LIBERTY HIGH SCHOOL Administration and Student Commons Modernization

Addendum 02

DECEMBER 21, 2020

Architect's Project No.: 1783.00

SHEET NUMBER ADDENDUM 02 AB4.1

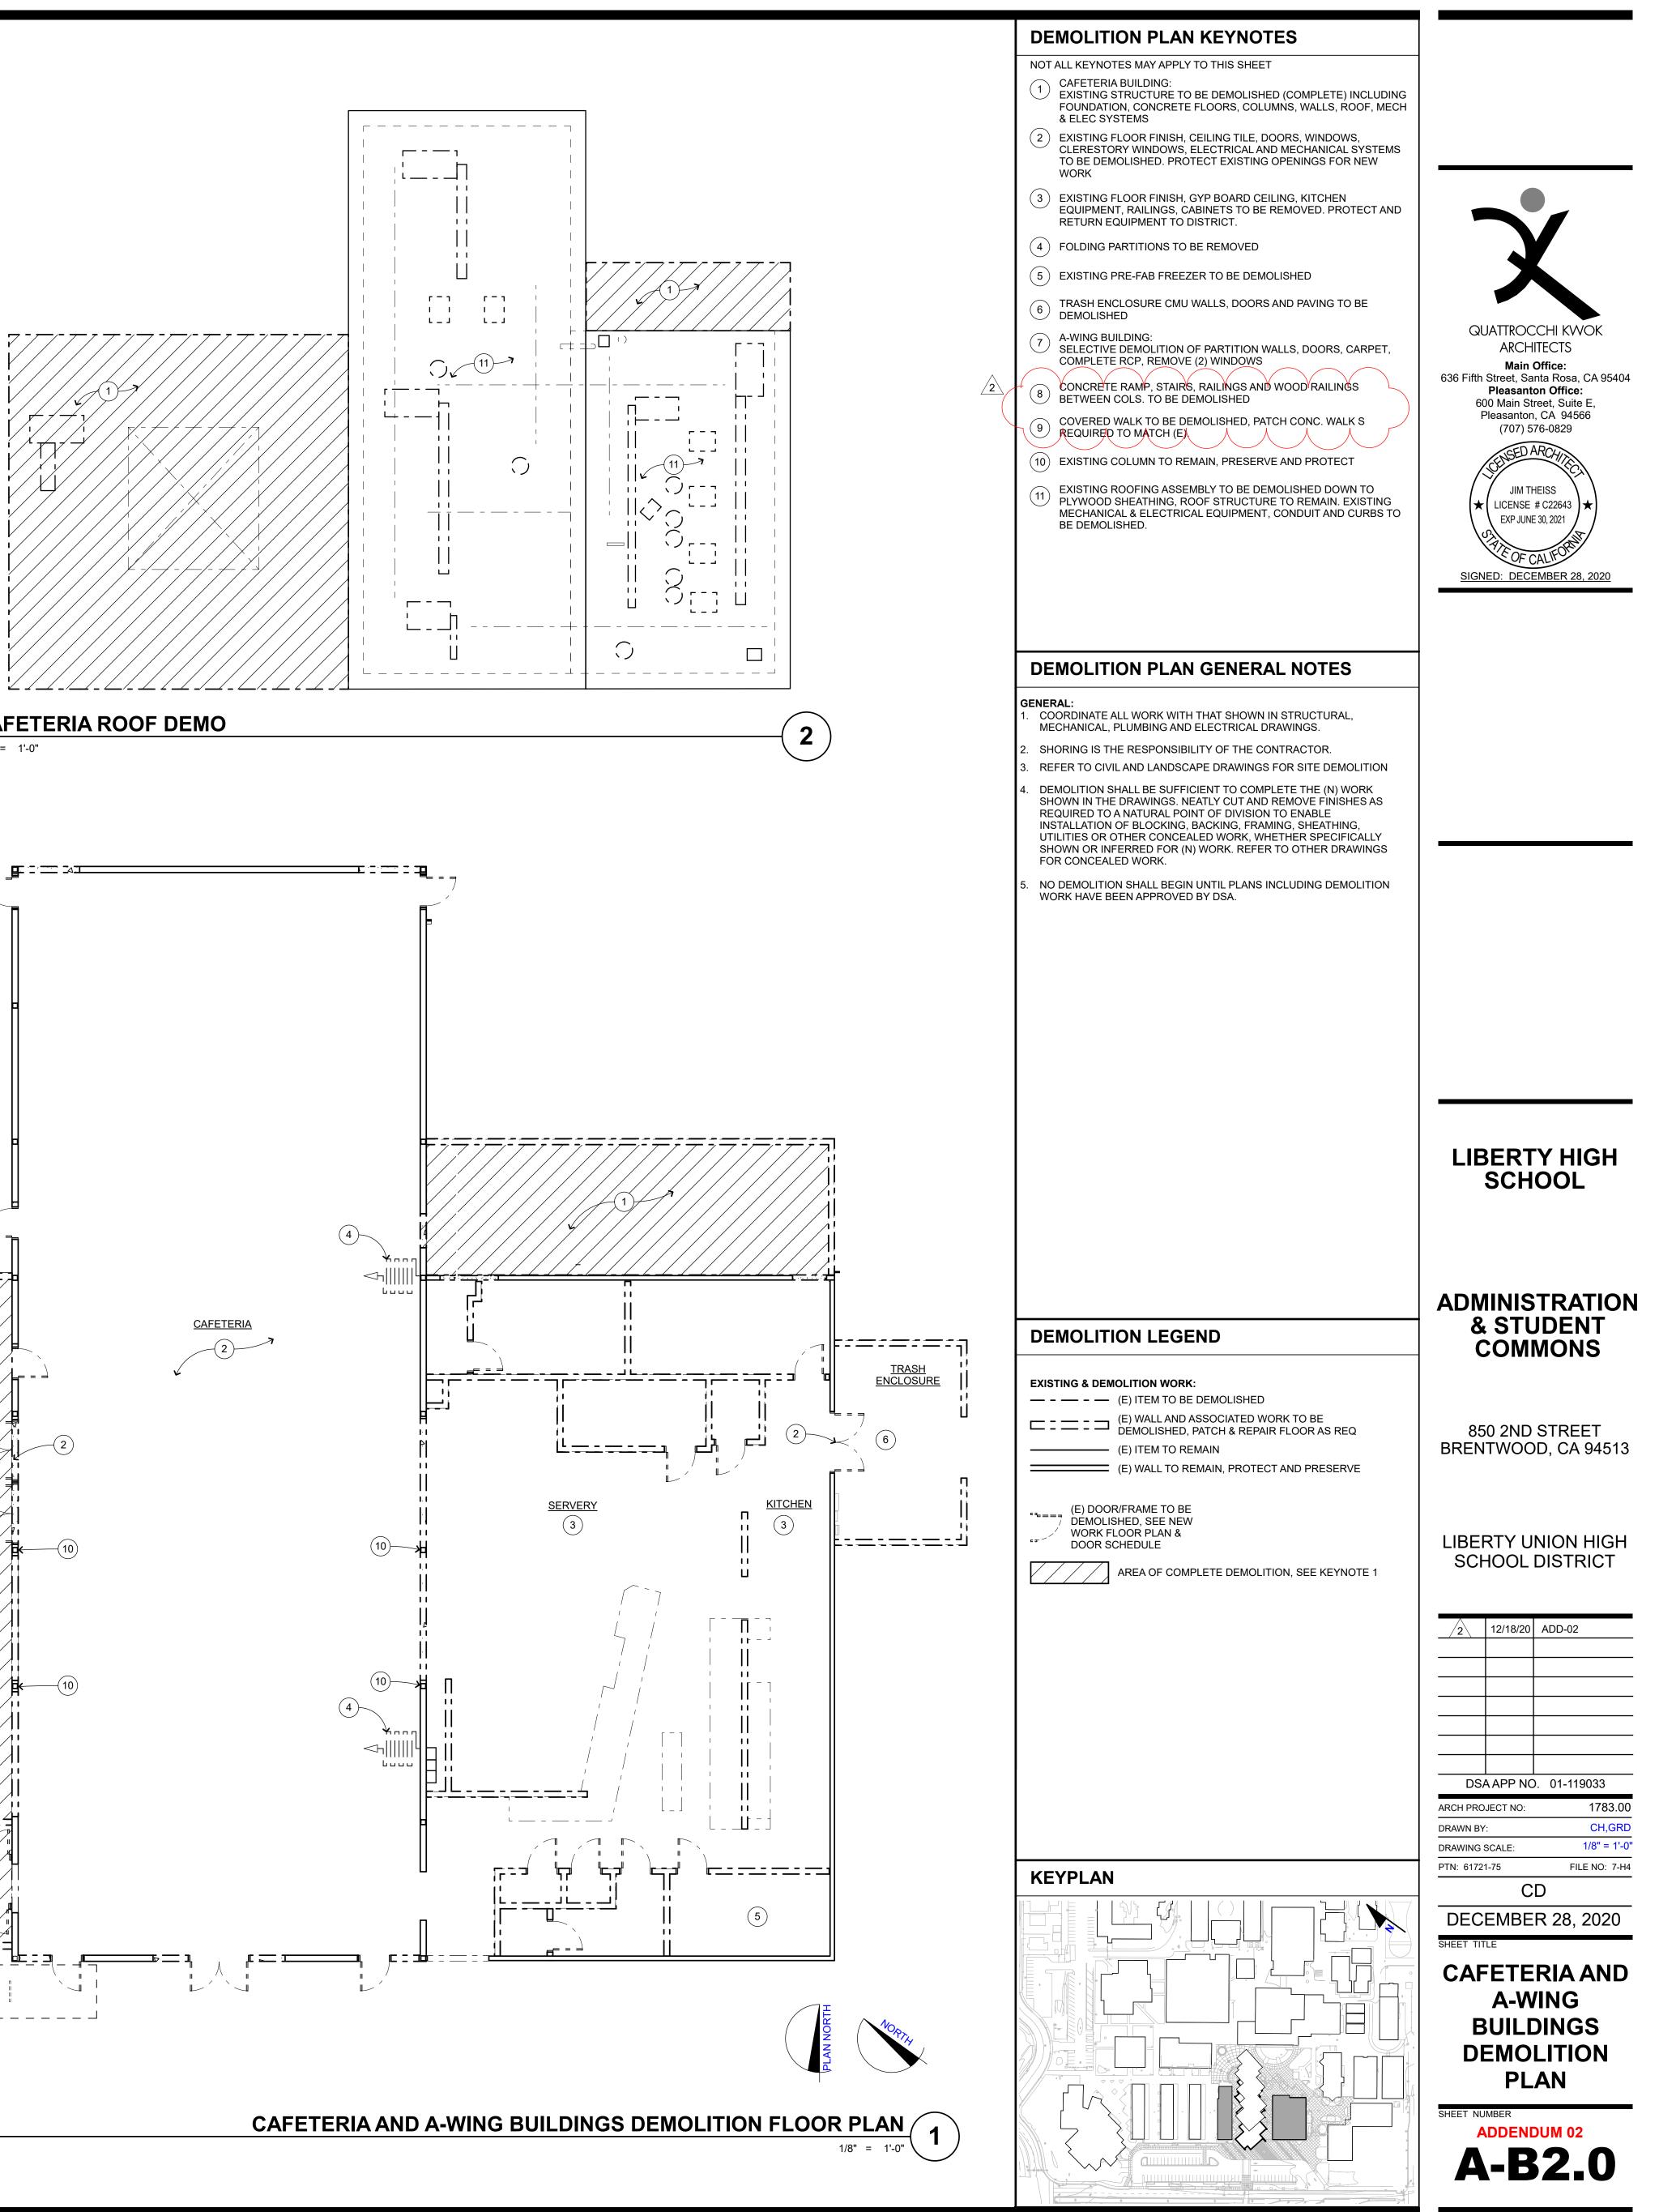
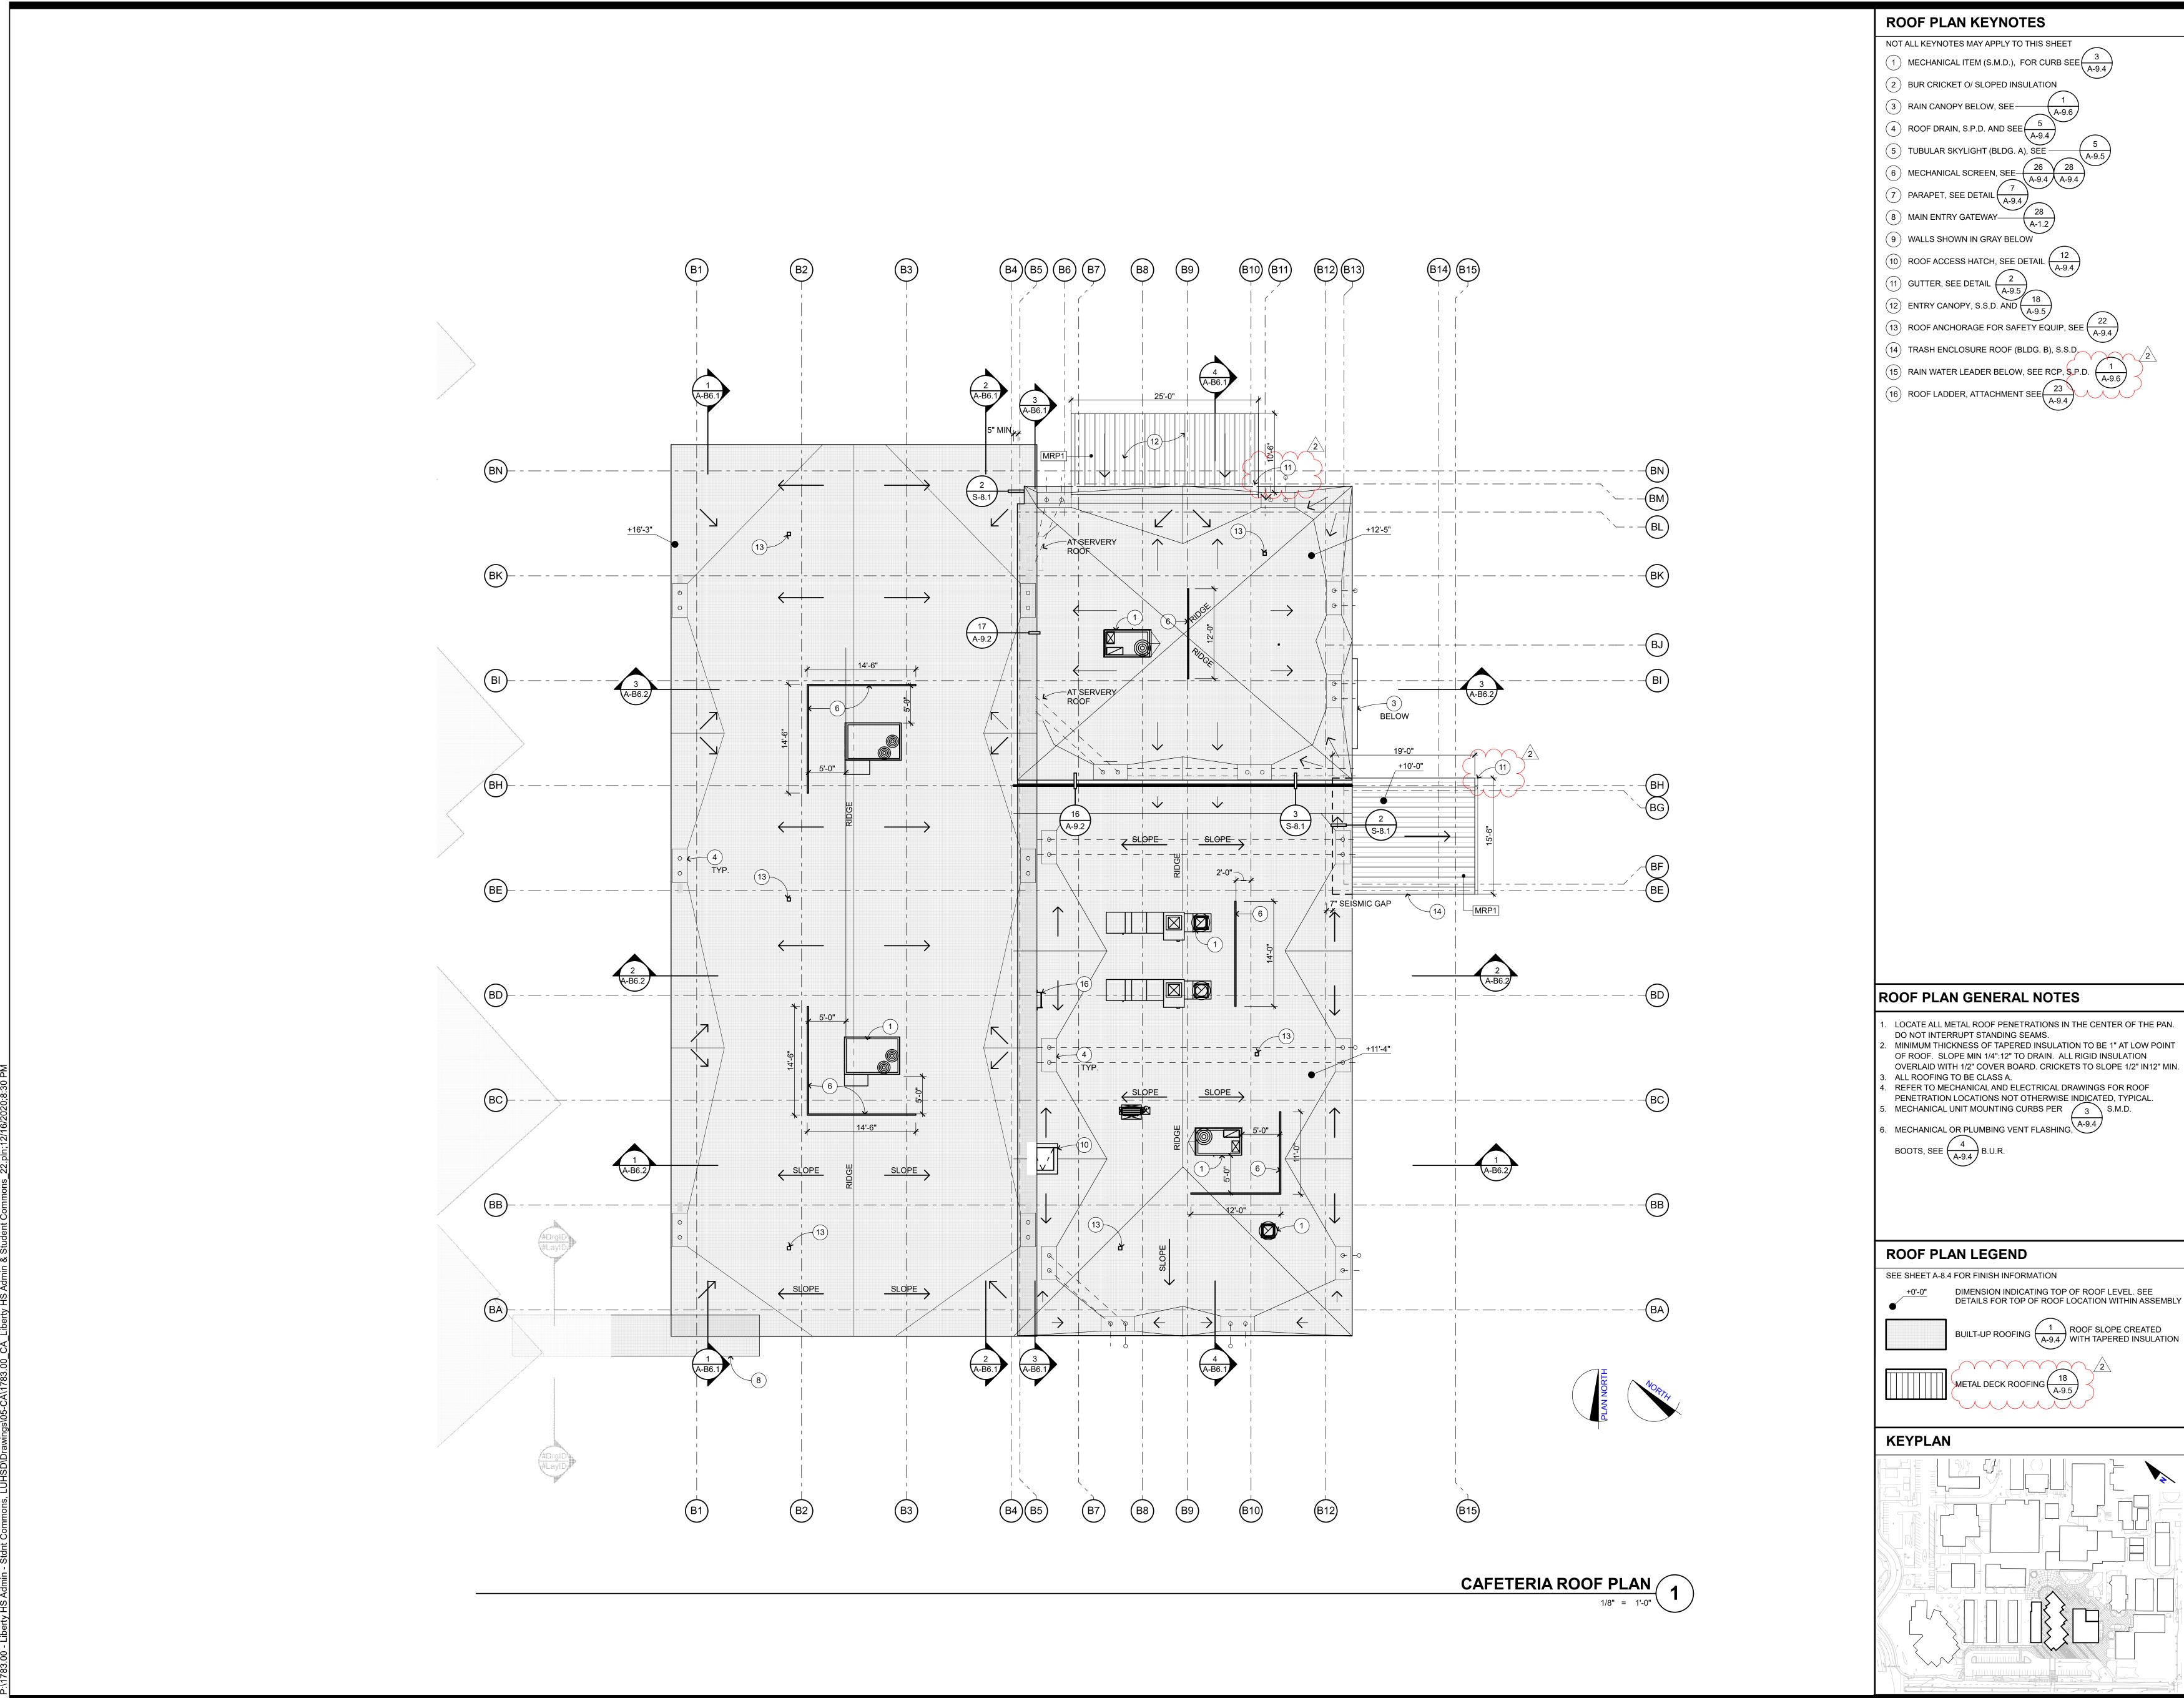
The following drawings dated December 18, 2020 denoted **Addendum 02** supersede and replace previous drawings with the same titles:
